OCONEE NUCLEAR STATION, UNIT 1

AMENDMENT TO FACILITY OPERATING LICENSE

ATTACHMENT TO LICENSE AMENDMENTS

SAFETY EVALUATION BY THE OFFICE OF NUCLEAR REACTOR REGULATION

Figure 3.5.2-1A2

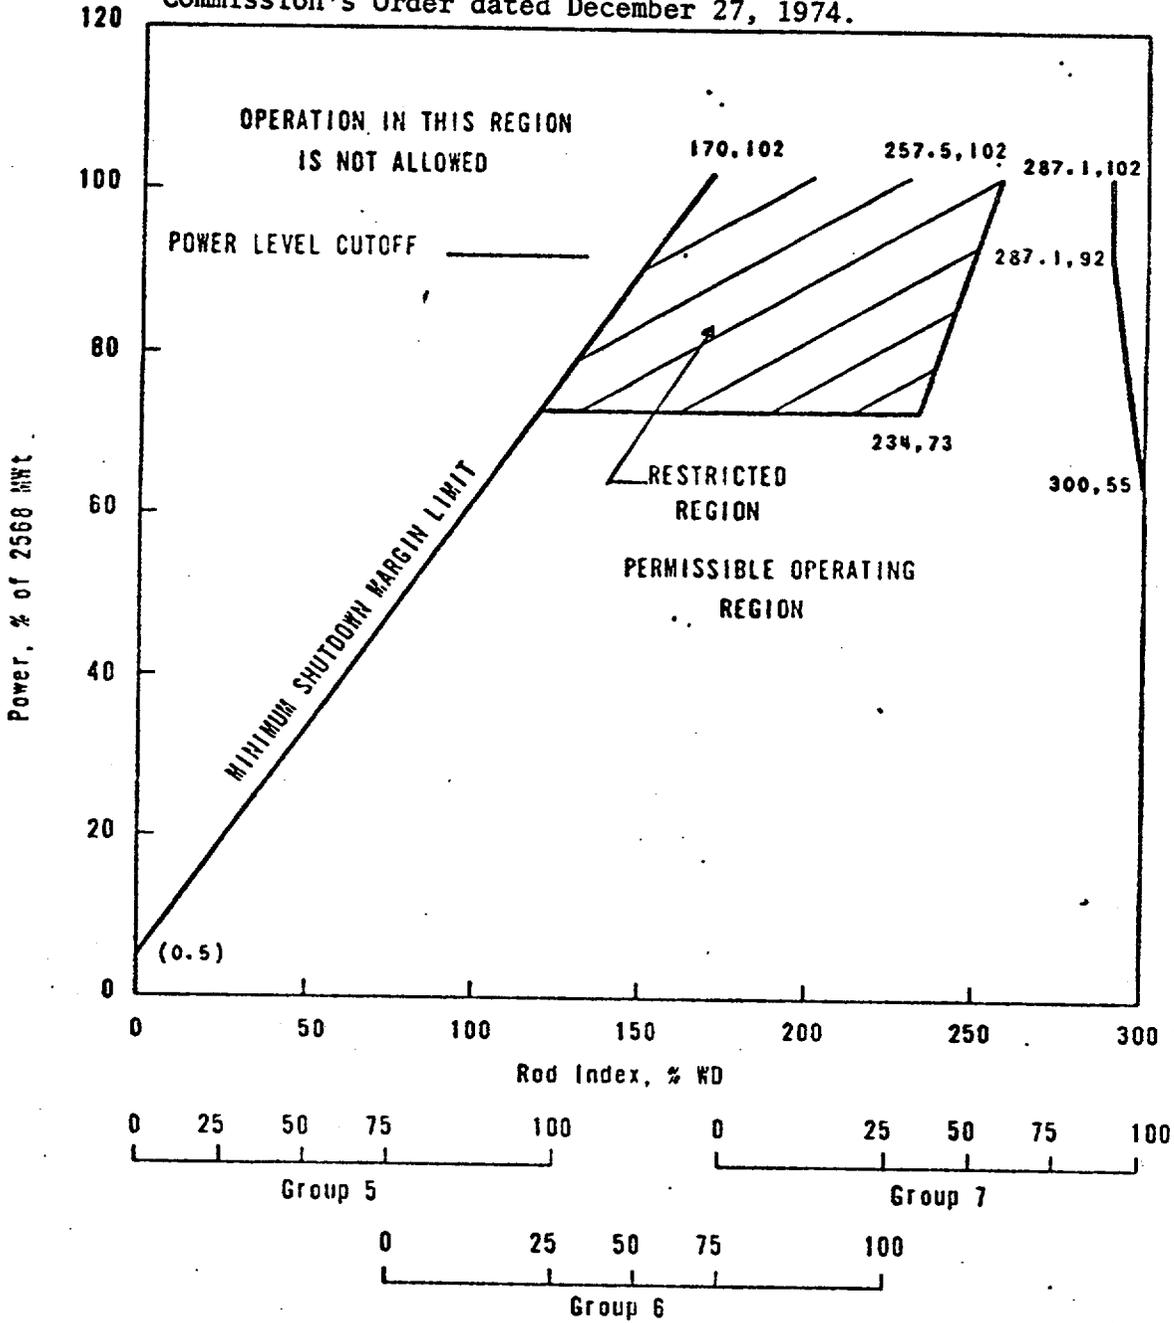
These amendments provide Oconee Unit 1 control rod position and operational power imbalance limits for four-pump operation applicable to the period after 245 + 10 Effective Full Power Days of operation.

ROD POSITION LIMITS FOR 4 PUMP OPERATION APPLICABLE TO THE PERIOD AFTER 245 ± 10 EFPD, as provided for in the Commission's Order dated December 27, 1974.

Figure 3.5.2-3A

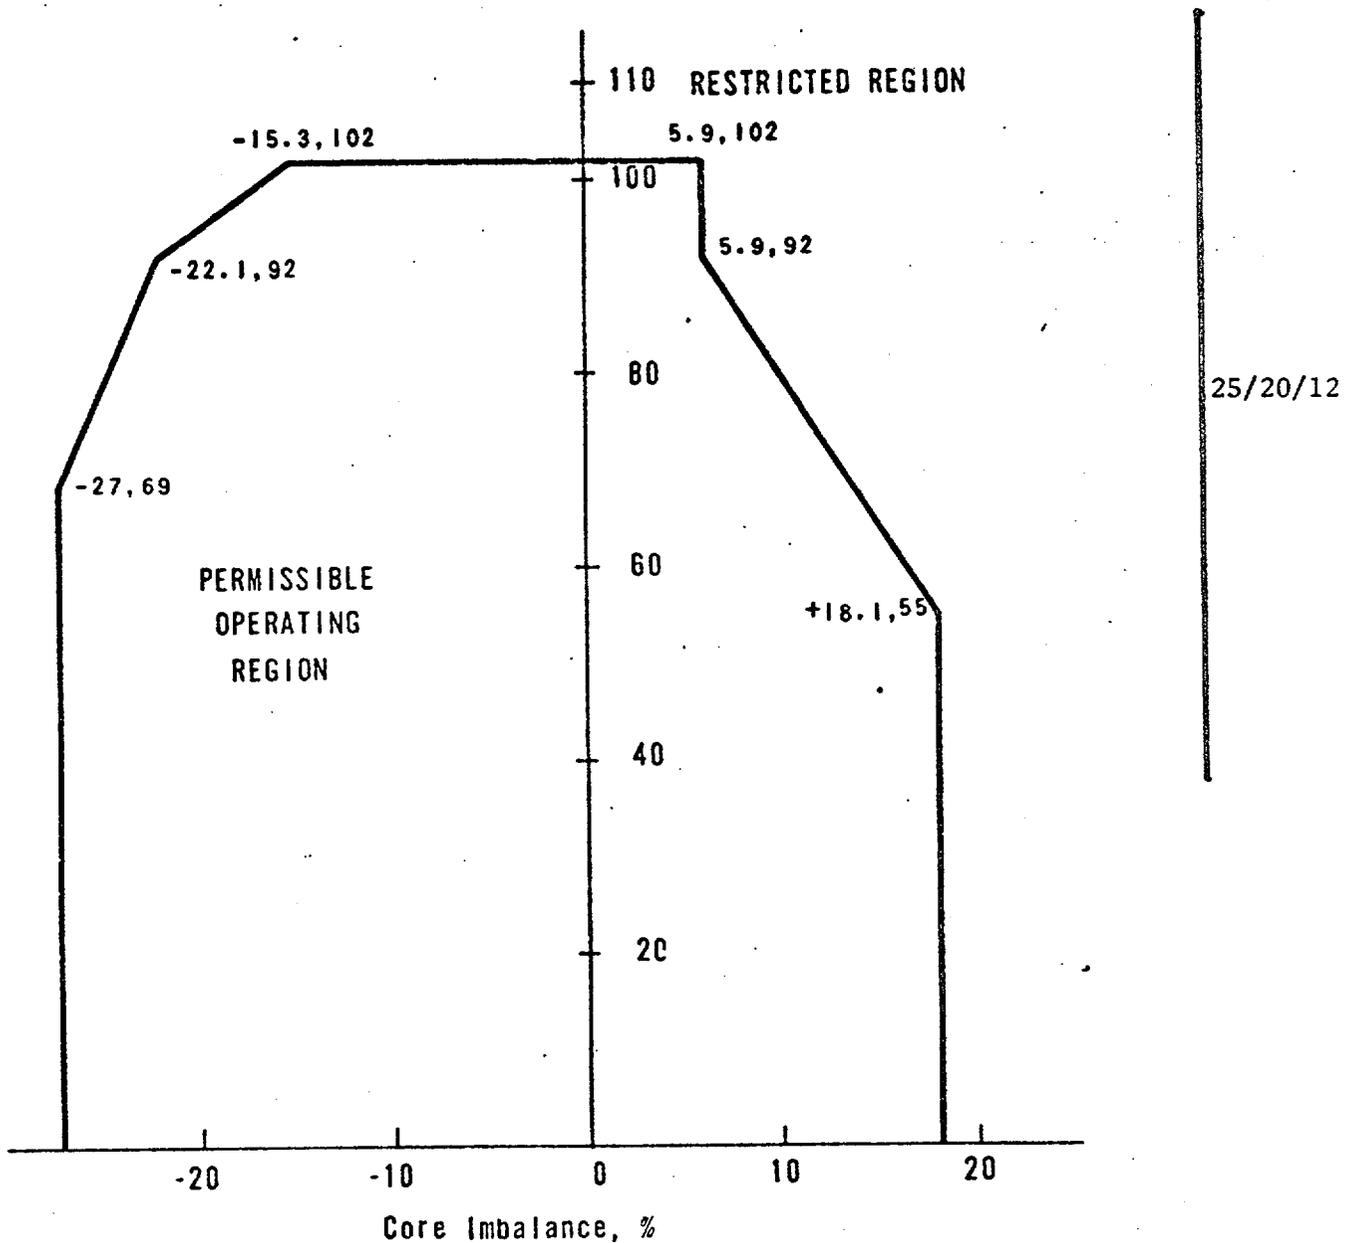
(for operation beyond 250 EFPD) was recognized and provided for in the Order and, with respect to the axial power imbalance limits, the new limits are more restrictive than those in the Order.
